ROTORUA MUSEUM

Summary of Issues to Date – 04/09/2017

Provided below is a brief summary of the numerous issues present at the Rotorua Museum to date. These issues include findings from; the Detailed Seismic Assessment by GDC Consultants Ltd; Timber Deterioration Assessment by Prendos NZ Ltd and detailed investigation by TDC Ltd.

Concrete wall elevation (yellow) with steel frame (grey) (left) and steel frame detail (right).

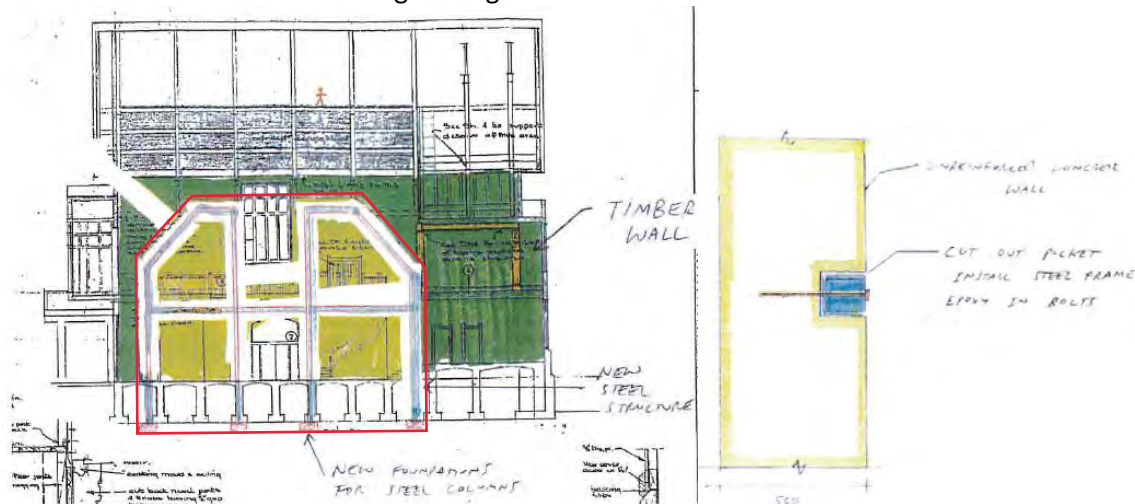
1. Unreinforced concrete full height gable end walls are weak against out of plane (perpendicular) forces. Strengthen walls with new structural steel frames, rebated into concrete, through concrete floor and into new concrete footings in the basement. Rebate can be filled after installation of steel and finished over to match existing heritage fabric.

Diagram of full height concrete wall overturning due to out of plane forces on the left v.s. full height concrete wall braced against overturning with strengthened low concrete wall (left) and photo of low concrete wall below mezzanine (right).

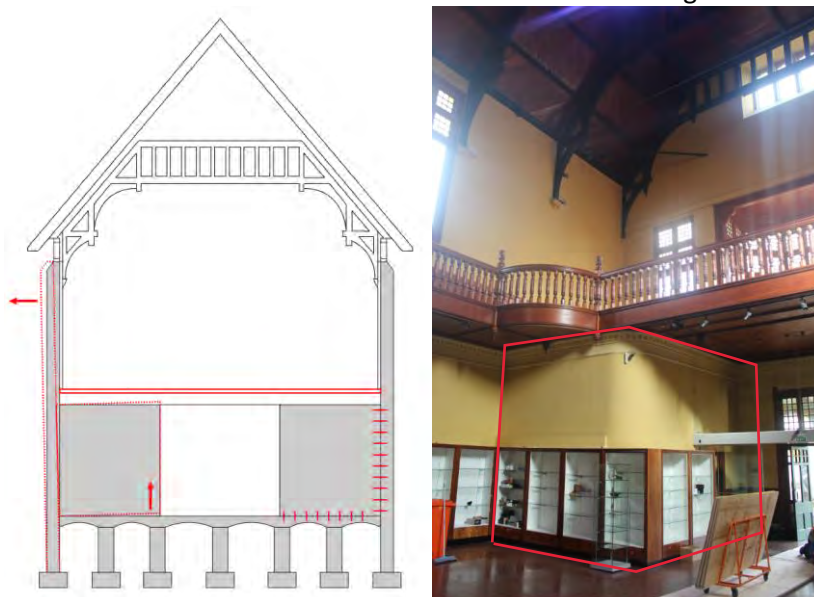
2. Unreinforced concrete walls lack bracing against overturning from out of plane (perpendicular) forces. Create new structural walls perpendicular to the concrete walls to provide bracing. Utilize existing low concrete walls by strengthening their connection to the full height unreinforced concrete walls. Install new steel brace frames into existing timber framed walls.

Cracked rafter (left) and severely moisture damaged valley rafter (right).

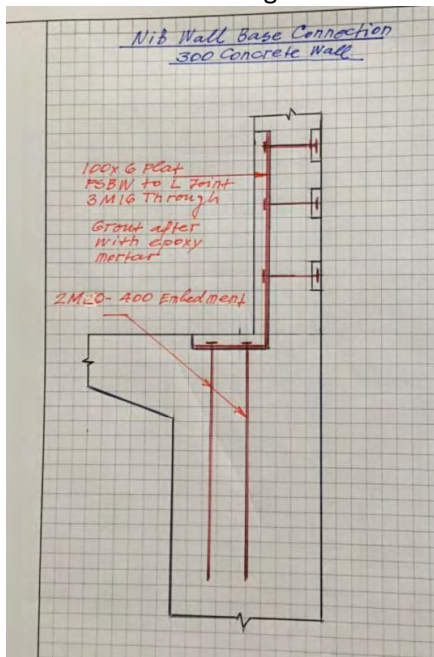
3. Numerous timber roof framing and sarking elements have decayed and their connections to the timber top plates have deteriorated due to moisture damage caused by severe leaking of roof tiles over time. Replace decayed timber and install new connections to top plate.

Roof tiles have broken and slid completely off roof (left) and active water leak through tiles on roof framing (right).

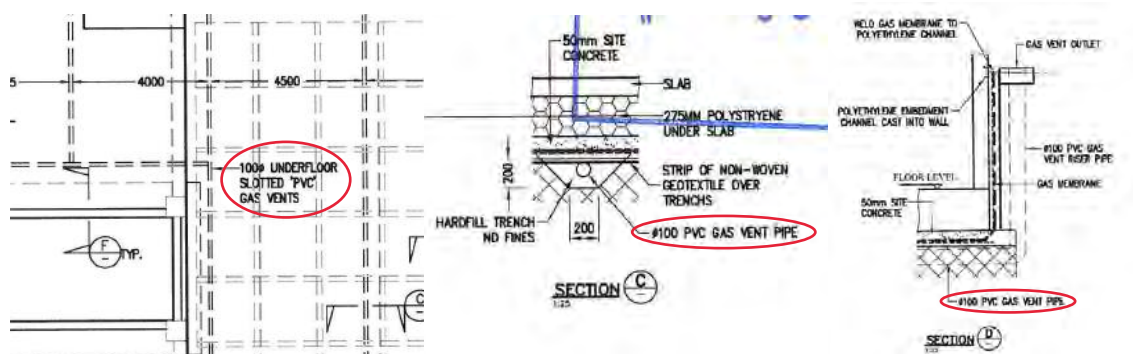
6. Clay roof tiles are leaking severely and causing widespread moisture damage to both structural and service elements of the building. If the moisture damage continues to framing elements the timber decay will cause a severe structural weakness. Repair or replacement of the roof tiles is required to prevent any further decay of timber framing elements. Replacement of the existing heavy clay roof tiles with a lightweight alternative will also reduce the seismic demand on the overall structure and may reduce the scale and complexity of structural upgrade works required. Removal of the existing roof will also allow structural works in the roof space to be carried out more easily.

Damaged roll of membrane at time of construction (left) and photo of lift shaft membrane installation (right).

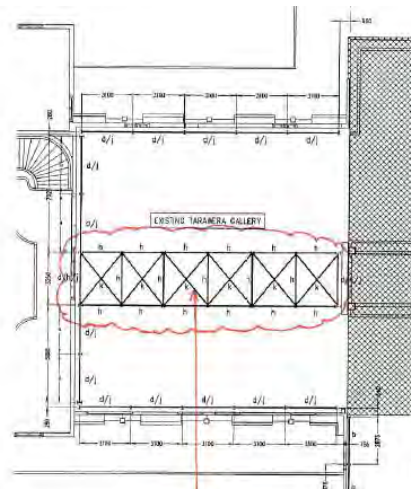
9. Membrane below slab and to exterior of basement and lift shaft walls has failed. Moisture is seeping through masonry block walls, leaving calcium deposits on basement walls and sulphur stains in the lift shaft. Re-seal concrete floor slab and masonry block walls with tanking membrane.

Sketch detail of new steel brace frame to be installed.

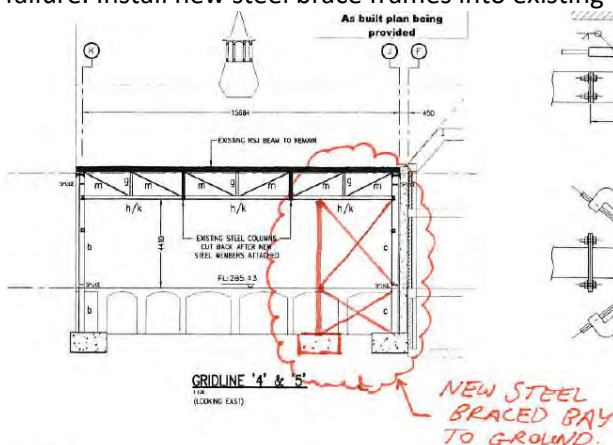
11. Central steel portal likely to experience excessive deflection under seismic event leading to failure. Install new steel brace frames into existing timber partition walls either side of Pukaki.

Cracked timber roof framing.

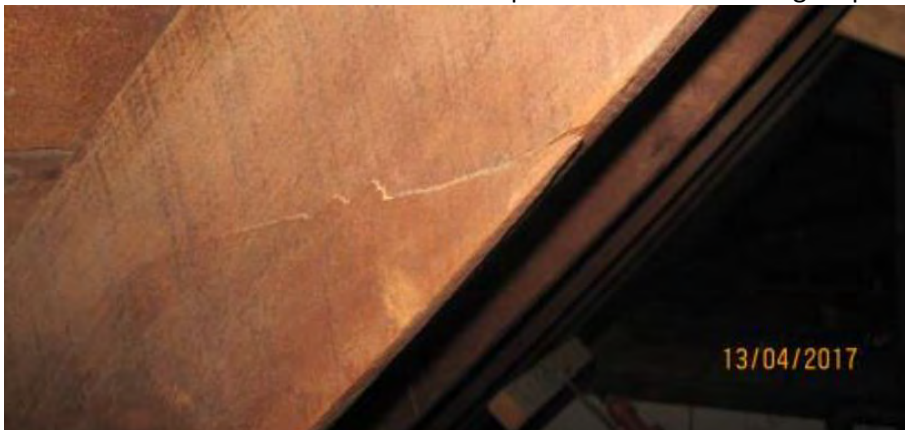
12. Timber roof beam above atrium has experienced some cracking. Replace beam and connections.

Approximate area of mezzanine floor required for structural diaphragm.

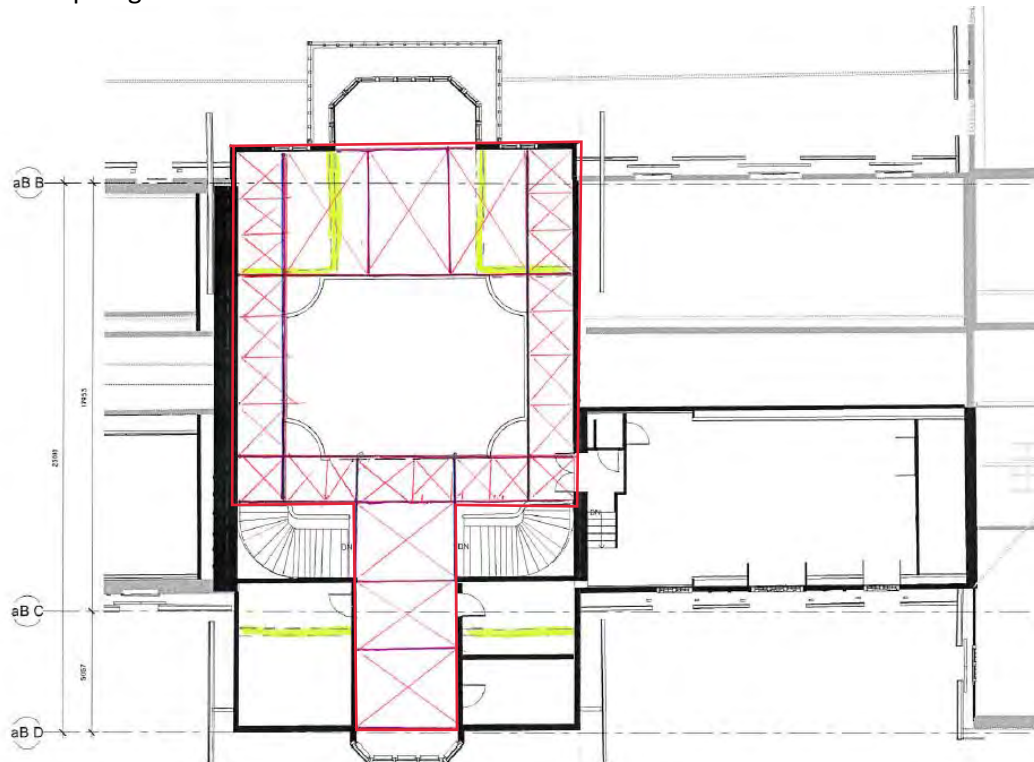
13. Lack of horizontal plane bracing to unreinforced concrete walls at mid height. Install a new horizontal floor diaphragm by removing existing mezzanine floor lining, installing steel bracing into the floor cavity and installing new structural plywood flooring screw fixed to joists to create effective floor diaphragm.

Long section of atrium showing (red) approximate location of concrete walls requiring footings to be widened.

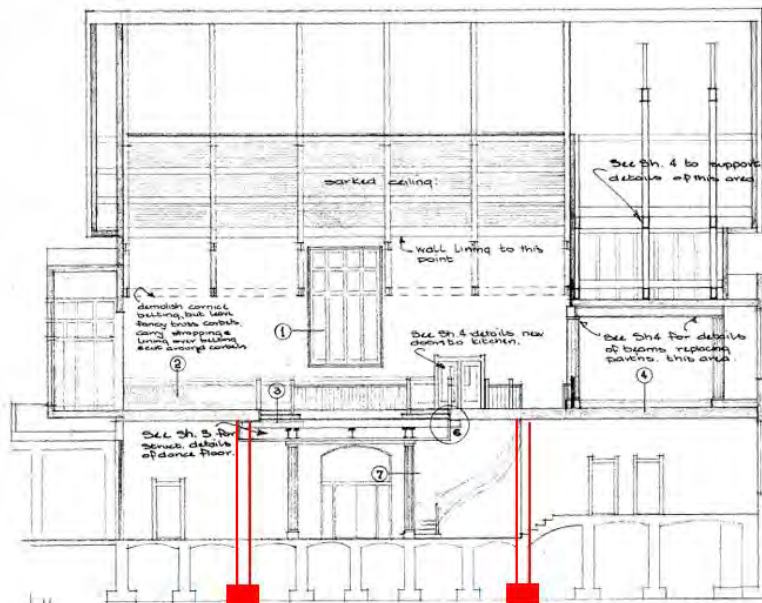
14. Selected foundation footings in Atrium below concrete walls running in the north-south direction lack bearing capacity. Footings need to be widened.

Sketch detail of plate to stud fixing (left) and example of Tylok plate to be used to strengthen timber connections (right).

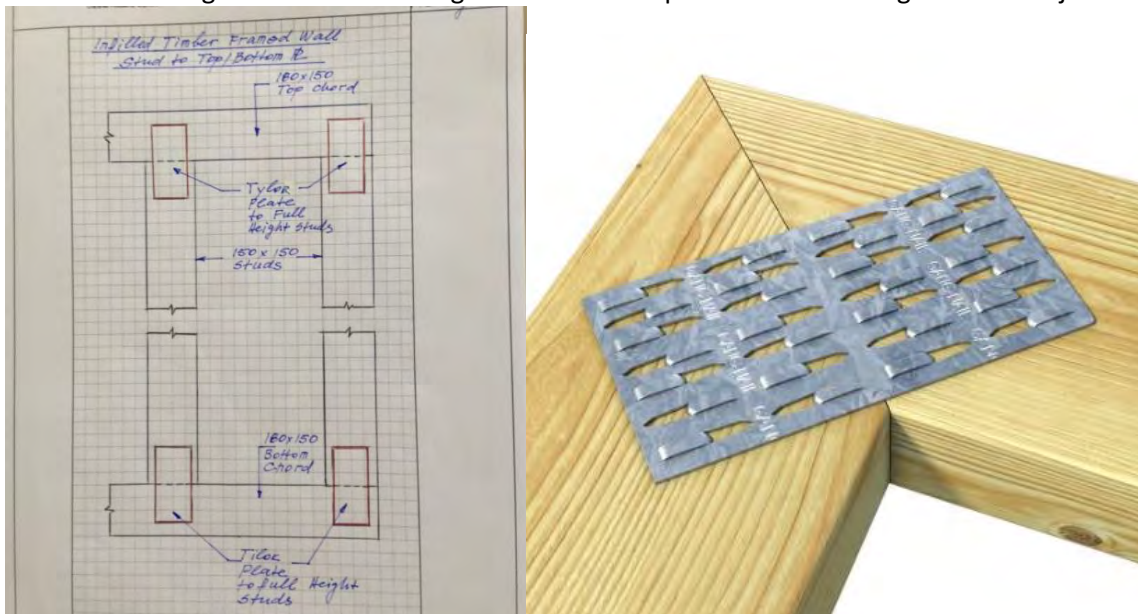
15. Existing timber framed walls lack lateral bracing capacity and require strengthening to create structural bracing walls. Remove lining and install steel plates over to strengthen timber joints.

Cross section of Intermediate North Wing showing approximate location (red) of required steel bracing in roof space.

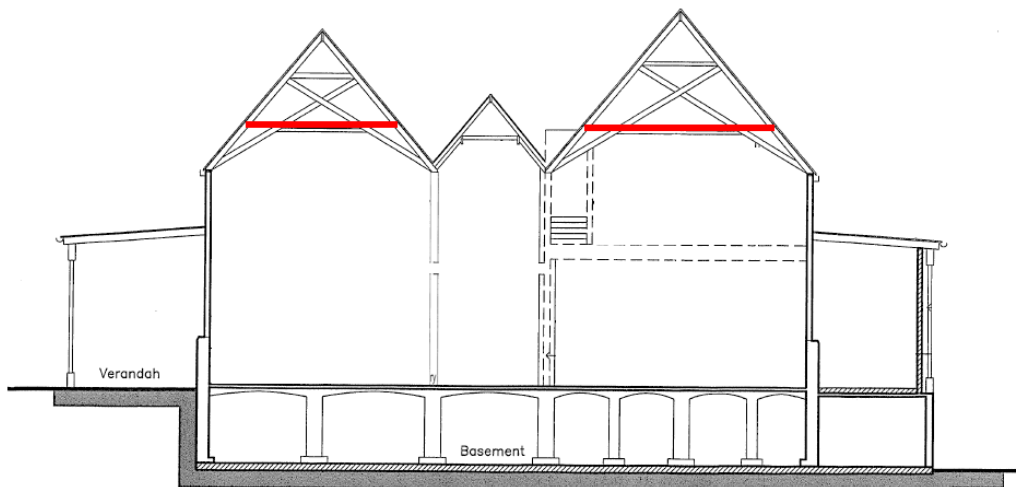
16. Lack of an effective roof diaphragm to tie together and strengthen global structure. Install horizontal steel cross bracing in roof space to create a structural diaphragm above the ceiling joists.
